UNITED STATES PATENT AND TRADEMARK OFFICE

APPLICATION NO.	FILING DATE	FIRST NAMED INVENTOR	ATTORNEY DOCKET NO.	CONFIRMATION NO.
10/766,025	01/29/2004	Masashi Makita	NS-US035169	2667

Office Action Summary

DETAILED ACTION

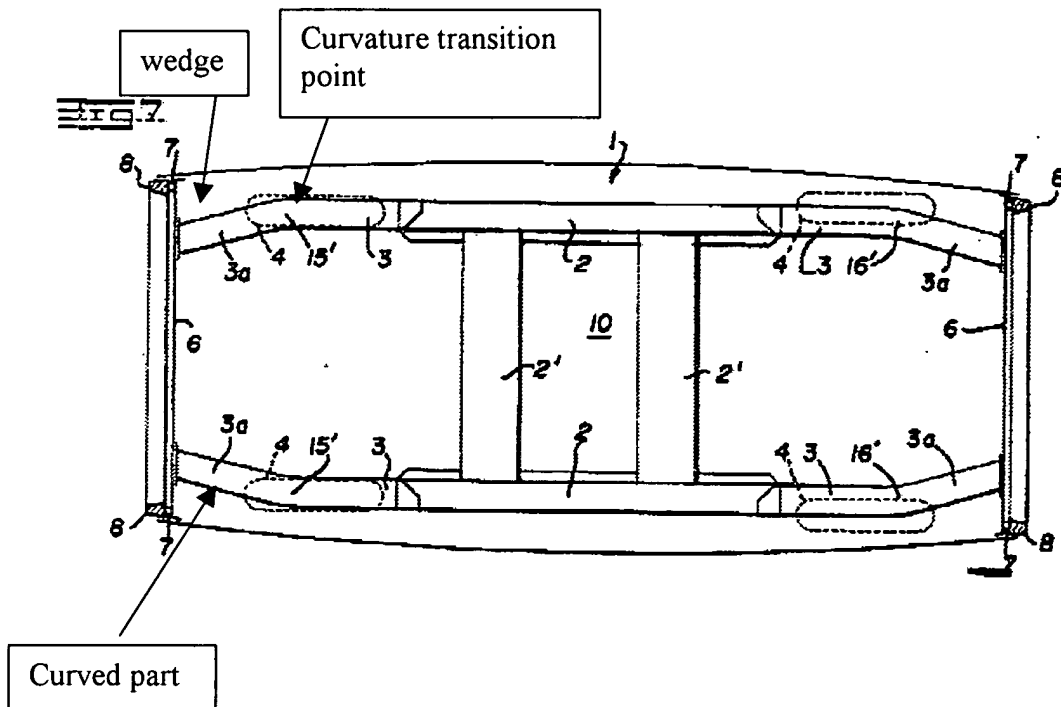
4. Claims 1, 2, 4, 6 and 18 are rejected under 35 U.S.C. 102(b) as being anticipated by Barenys (US Patent 3,171,669).

Regarding claims 1 and 18, Barenys discloses a vehicle body front section structure comprising: a pair of longitudinal frame members (2) configured and arranged to extend in a lengthwise direction of a vehicle on both widthwise sides of a front compartment, each of the longitudinal frame members (2) having a front end portion (3) with a curved part (see below) disposed forwardly of a curvature transition point (see below); and a widthwise frame member (6) having a back surface connected to the front end portions (3a) of the longitudinal frame members (2) such that the widthwise frame member (6) extends in the widthwise direction of the

vehicle, the curved parts being disposed at locations rearward connection points between the longitudinal frame members (3) and the widthwise frame member (6) such that a pair of wedge-shaped open spaces (see below) are formed between the back surface of the widthwise frame member (6) and corresponding wall surfaces of the curved parts that faces the back surface of the widthwise frame member.

Regarding claim 2, Barenyi disclose the vehicle body front section structure recited in claim 1, wherein each of the curved parts (3a) is formed as a separate entity from a main part of the longitudinal frame member (3) and is connected to a front end of the main part of the longitudinal frame member.

Regarding claim 4, Barenyi disclose the vehicle body front section structure recited in claim 1, wherein the curved parts (3a) are configured and arranged to curve inward (see above) in the widthwise direction of the vehicle from the curvature transition points.
